Addendum No. 1

North Valleys Integration Lemmon Drive Main Installation

PWP Bid No. WA-2016-011
October 15, 2015

EXHIBIT "A" APPLICANT INSTALLED CONDUIT ELECTRIC DESIGN	AUD#: 3001257144	GAS#: 3001257144	STL#: 3001257144	ELE#: 3001257144
SCALE: 1:50				
SHEET#: E-1

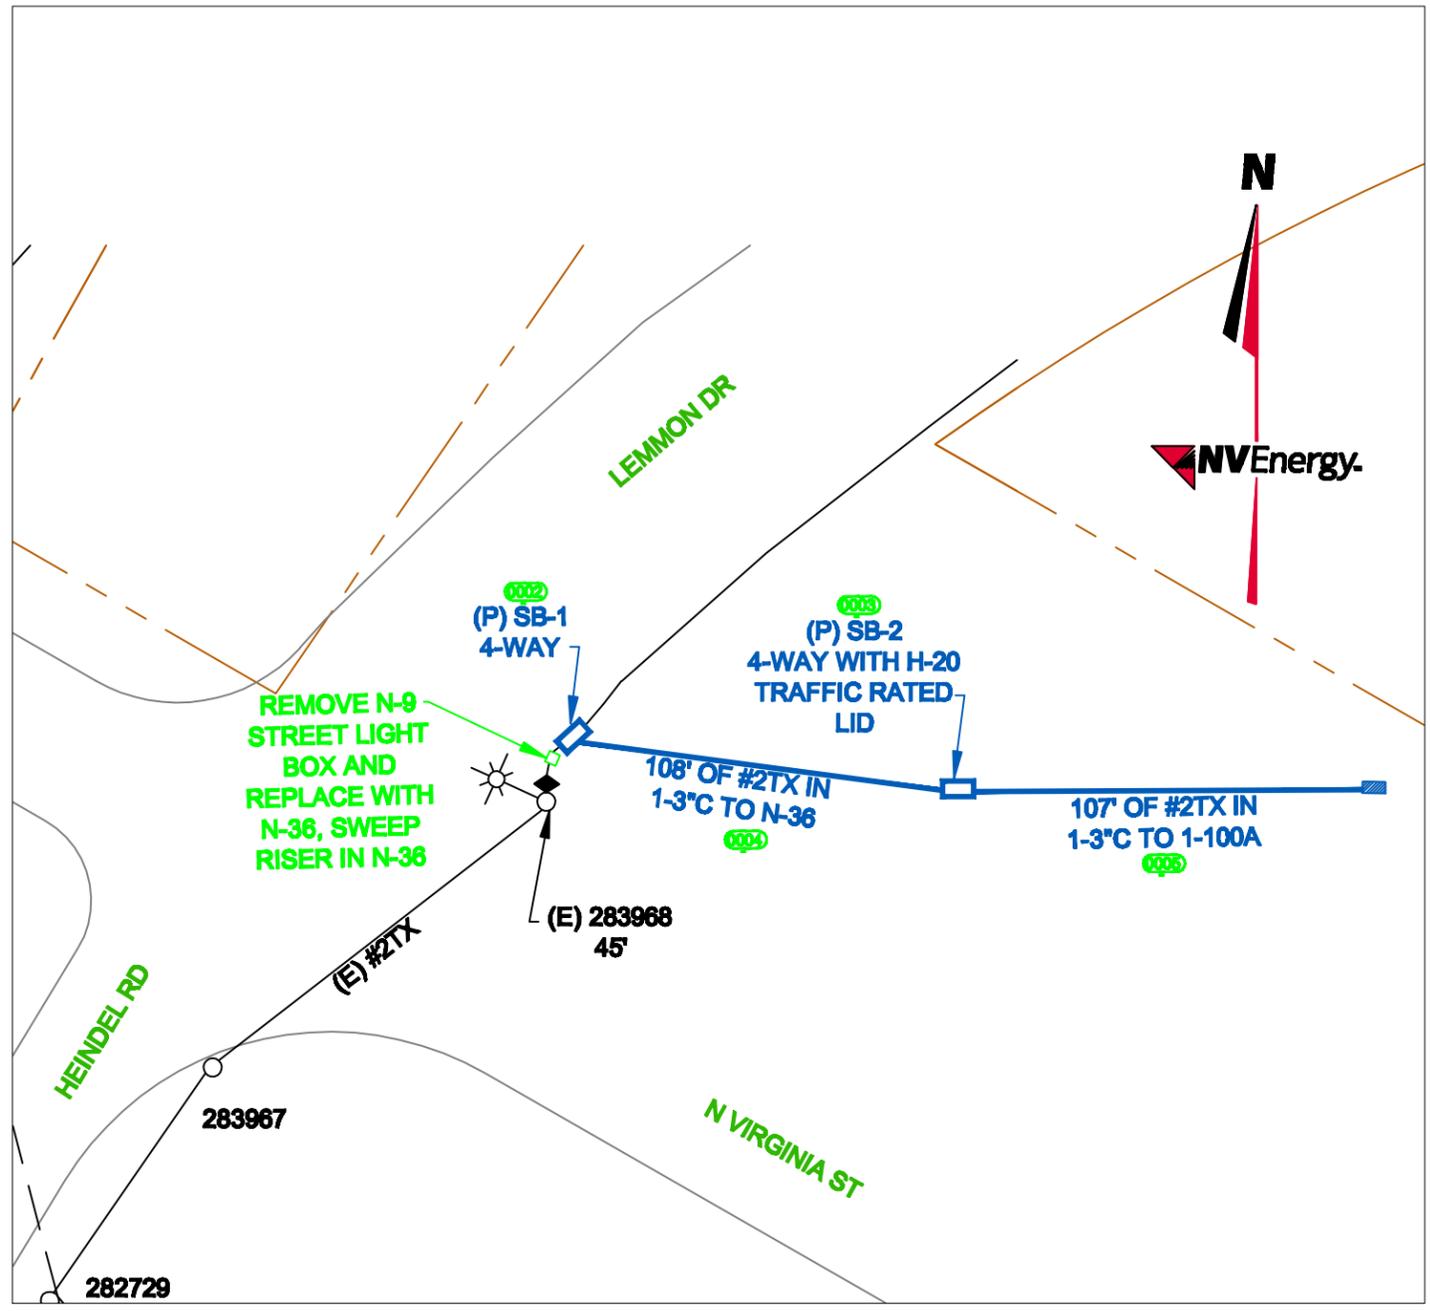
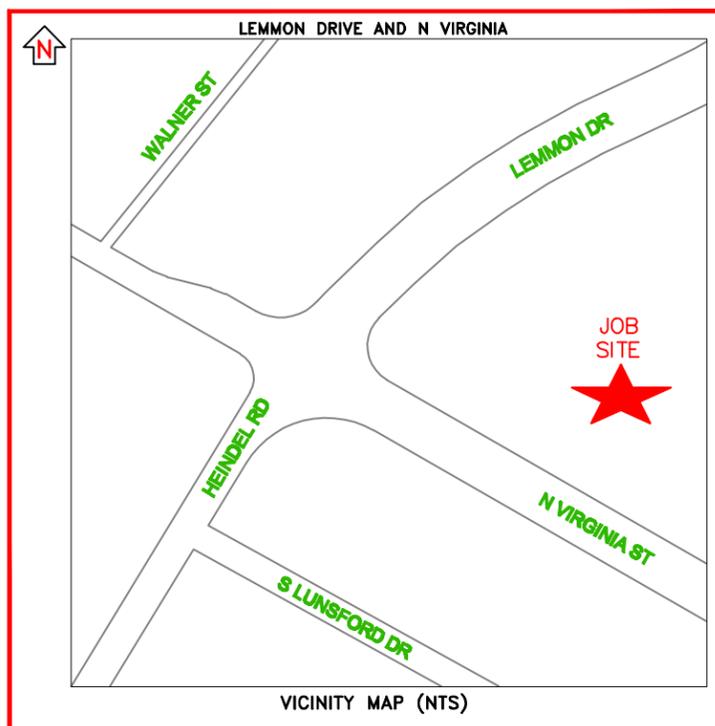
Drawing Sheet E7: The attached NV Energy Drawing shall be added to the Drawings as Sheet E7. **These improvements are to be constructed/installed by the Contractor as a part of the Work.**
